**Assessment of Five (5) Regulated-Size Trees #51 Through #55
At and Adjacent to
16336 Shady View Lane
Los Gatos, California**

Prepared for:
Mr. Azhar Khan, Assistant Planner
Town of Los Gatos Community Development Department

Field Visit:
Walter Levison, Contract Town Arborist (CTA)
1/29/2019

Report by (CTA)
1/31/2019

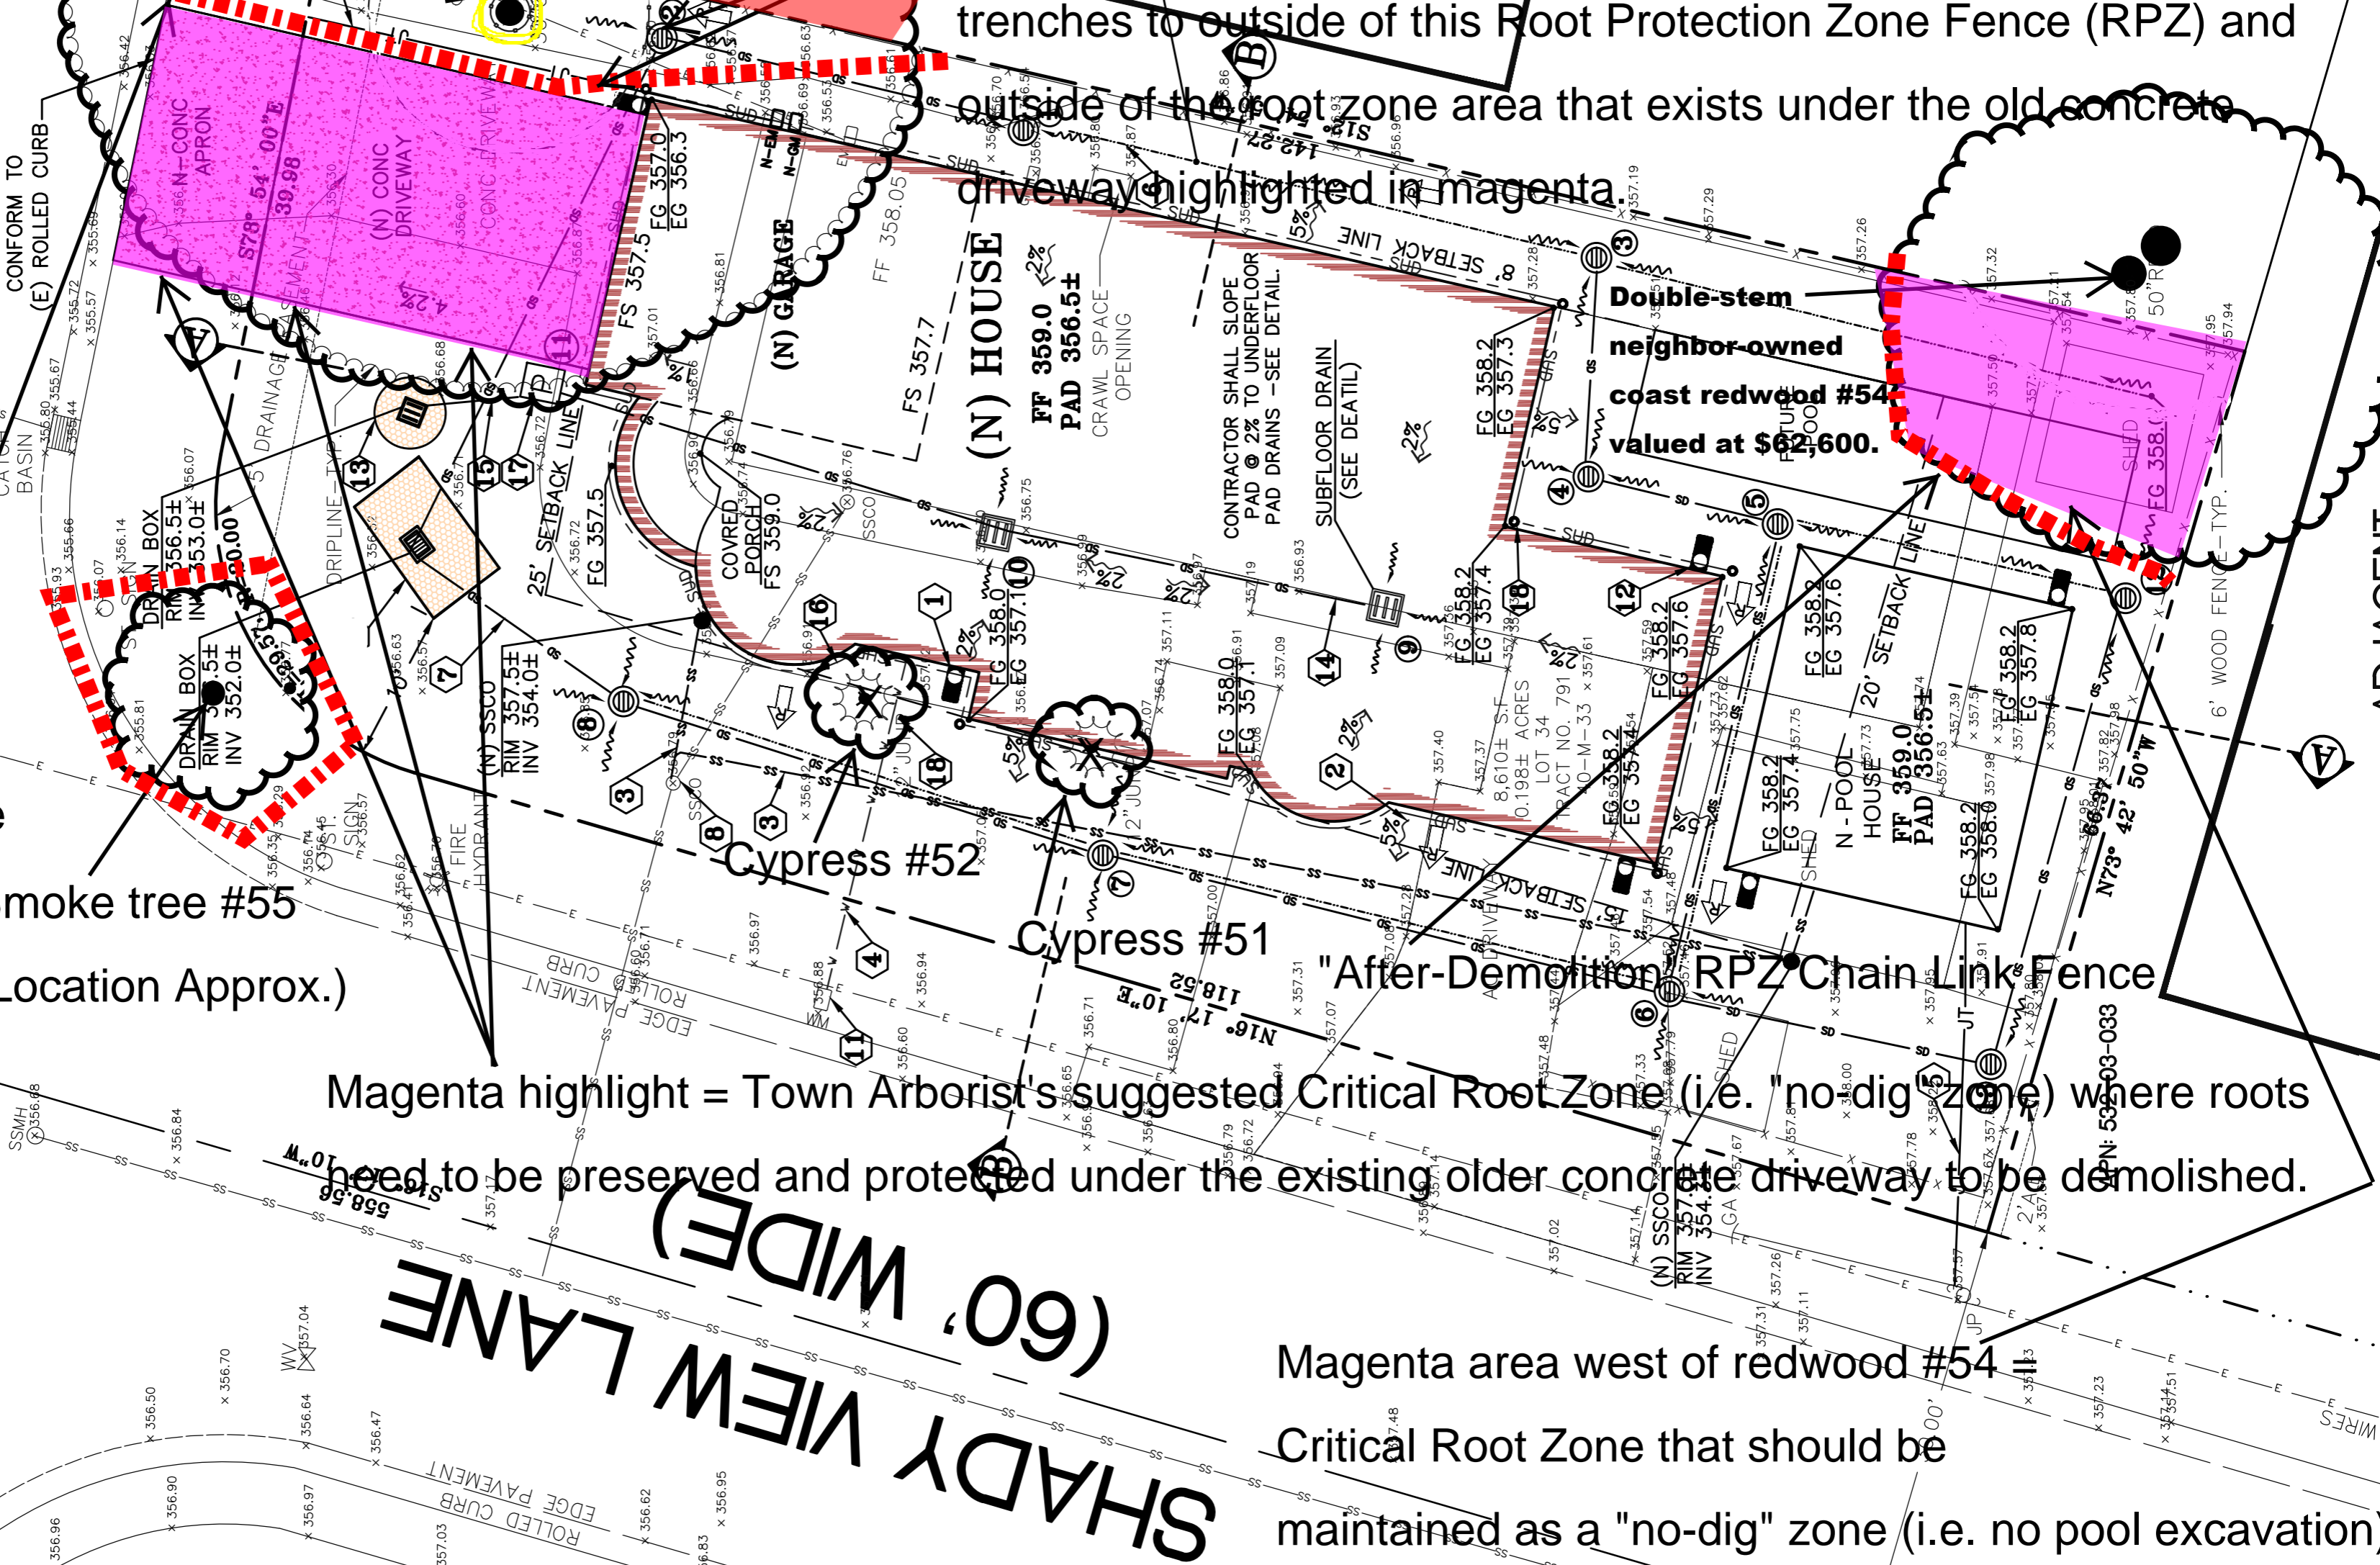
Relocate proposed joint trench and two separate storm drain
trenches to outside of this Root Protection Zone Fence (RPZ) and
outside of the root zone area that exists under the old concrete
driveway highlighted in magenta.

Double-stem
neighbor-owned
coast redwood #54
valued at \$62,600.
